Access Compliance Report

Public Rights-of-Way

(Curb Ramps)

| Intersection ID: 46697 | Main Street: GOLDFIELDS_DR | Cross Street: COFFEEBERRY_LN | Location: SW |

| ADA ID: B4CCBD511013 | Ramp Type: Perp | Initial Pass/Fail: Fail | Overall Compliance: No |

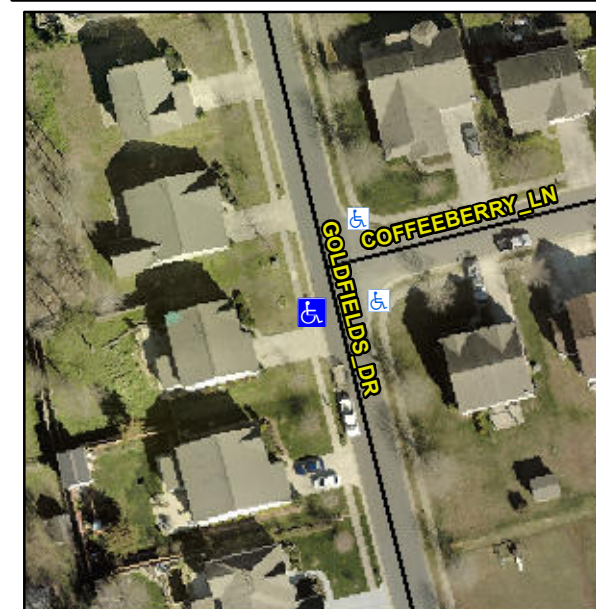
Not Found, R304.2.2

| Compliance | Description | Data | Compliance | Description | Data |
|------------|-----------------------|------|------------|-----------------------------|------|
| N/A | Ramp Length (in) | 48.0 | No | Ramp Slope (%) | 8.7 |

Remove & Replace Entire Ramp.
